PCN/21/010/C+N-US

Product range: Han / Han HPR

Title: Design Change Han 6HPR and Han 10HPR Hood

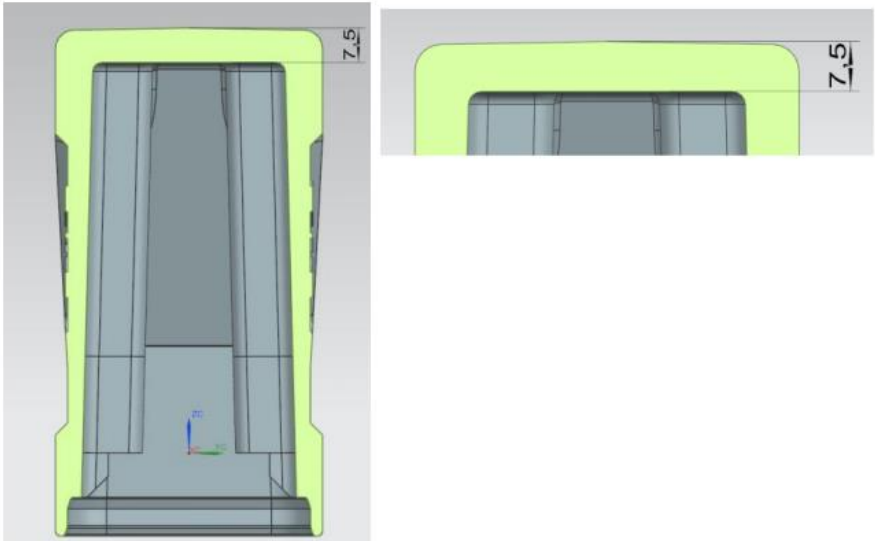
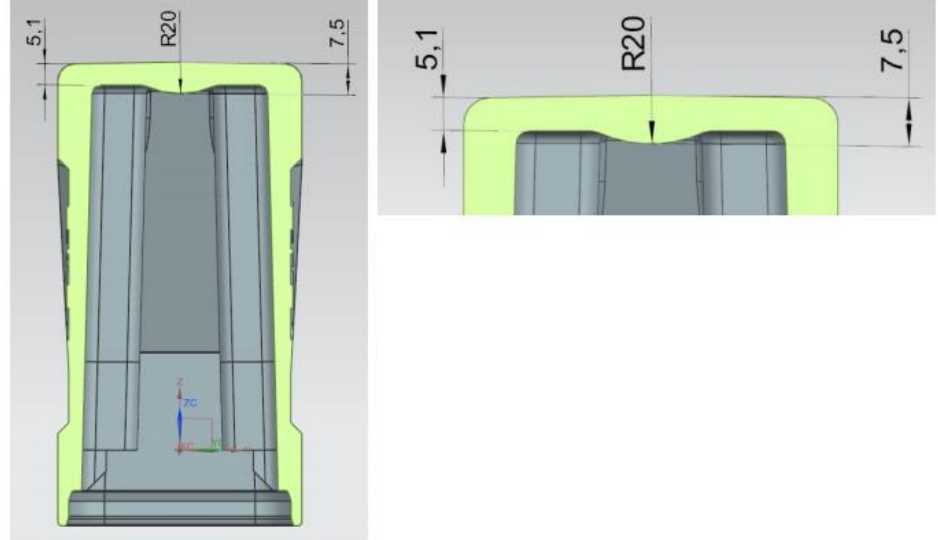
Old design		Flat contour on the inner bottom of the hoods
New design		"Wave contour" on the inner bottom of the hoods
